SINCLAIR hille architects

Addendum #3

Project Name:	Concordia STEM Seward, NE
Project No.:	16022-05
Date Issued:	May 11, 2018
Bid Date:	Thursday, May 17, 2018

1 TECHNOLOGY - MAIN LEVEL FLOOR PLAN - AREA B

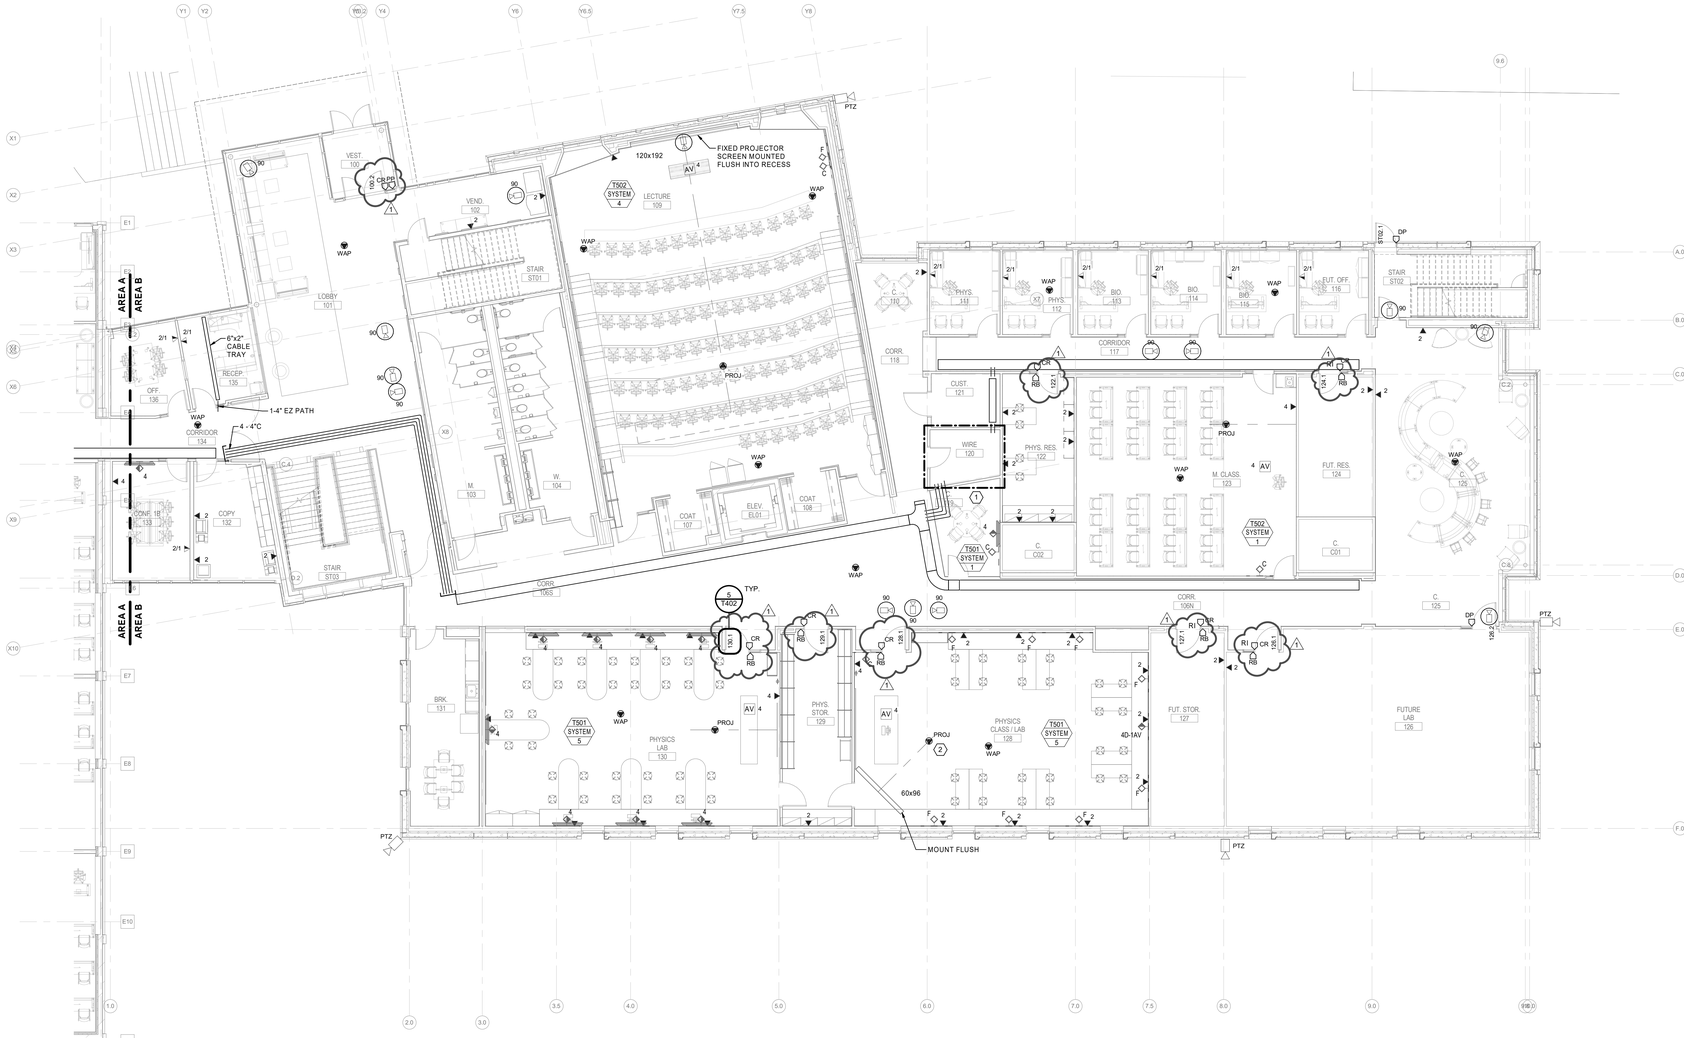
- Added Push Plate to Door 026.2
- Added Detail Callout to Door ST05.1
- Added Request-to-Exit Button to Door 020.1
- Added Request-to-Exit Button to Door 022.1
- Added Request-to-Exit Button to Door 016.1
- Added Request-to-Exit Button to Door 024.1
- Added Request-to-Exit Button to Door 025.1
- Added Request-to-Exit Button to Door 009.1
- Added Request-to-Exit Button to Door 013.1

1 TECHNOLOGY - UPPER LEVEL FLOOR PLAN - AREA B

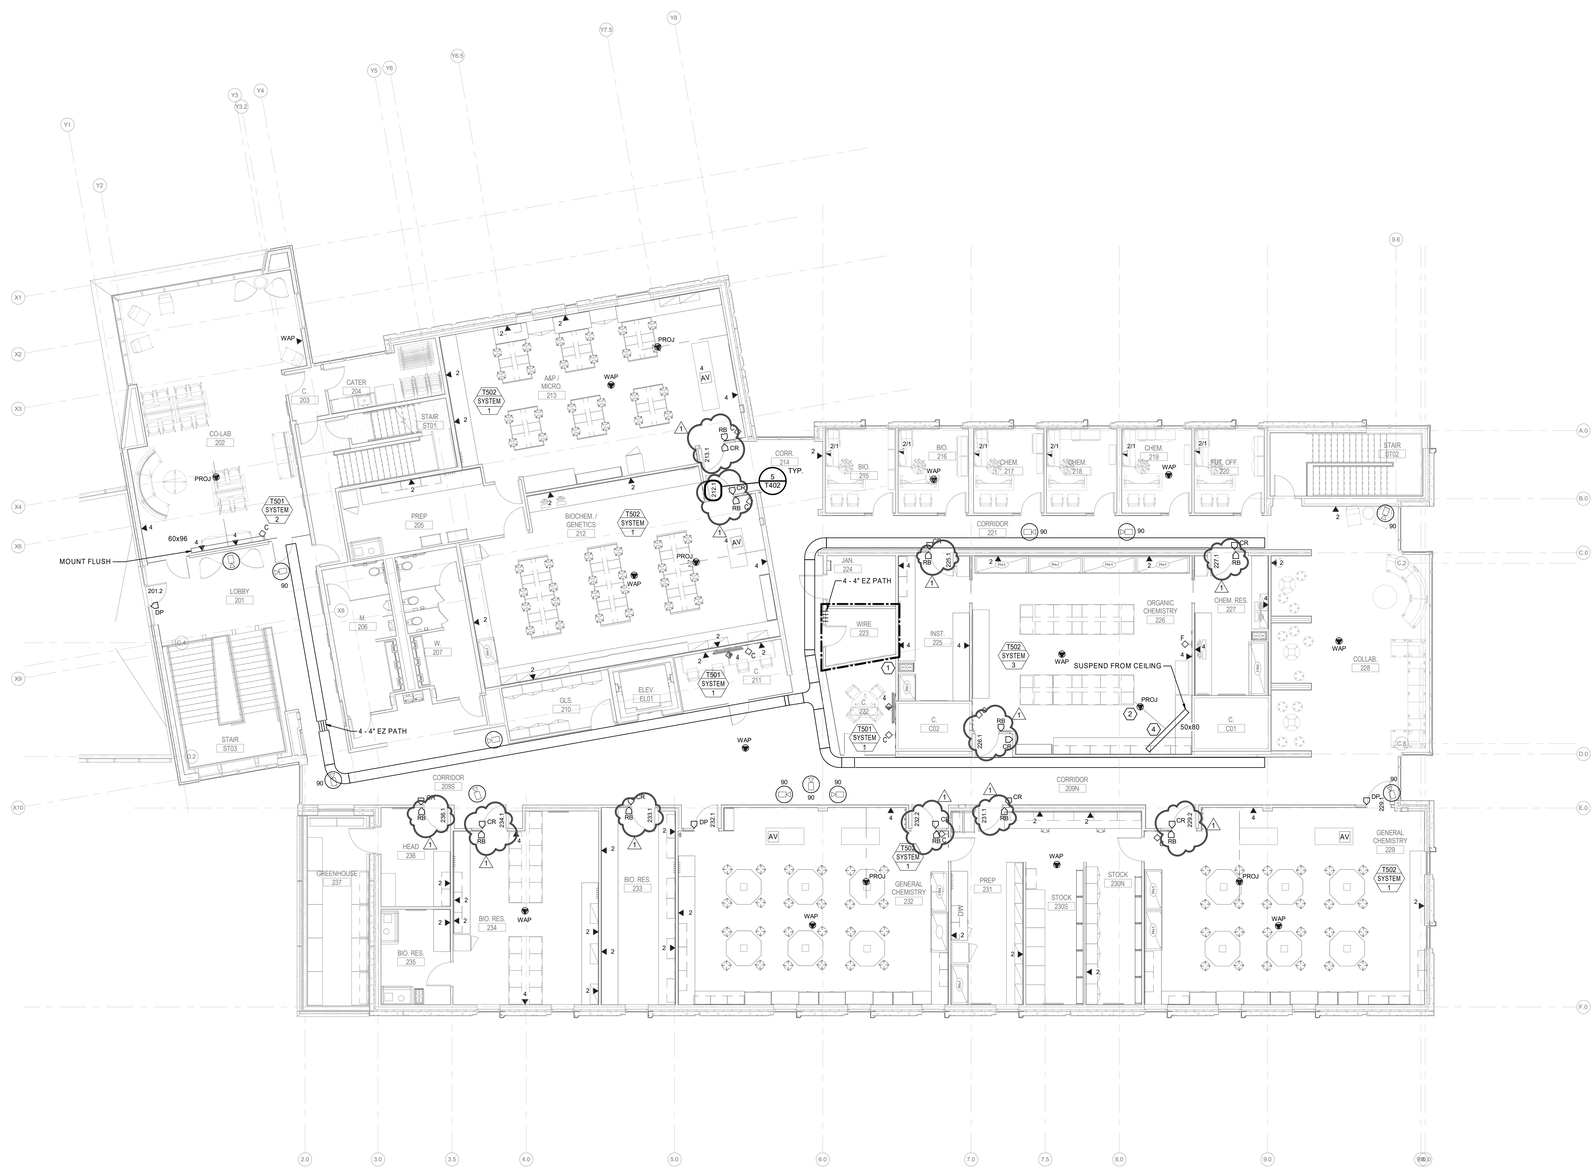
- Added Single Door Detail Callout
- Added Request-to-Exit Button to Door 229.2
- Added Request-to-Exit Button to Door 231.1
- Added Request-to-Exit Button to Door 232.2
- Added Request-to-Exit Button to Door 234.1
- Added Request-to-Exit Button to Door 236.1
- Added Request-to-Exit Button to Door 213.1
- Added Request-to-Exit Button to Door 212.1
- Added Request-to-Exit Button to Door 226.1
- Added Request-to-Exit Button to Door 227.1
- Added Request-to-Exit Button to Door 225.1
- Added Request-to-Exit Button to Door 233.1
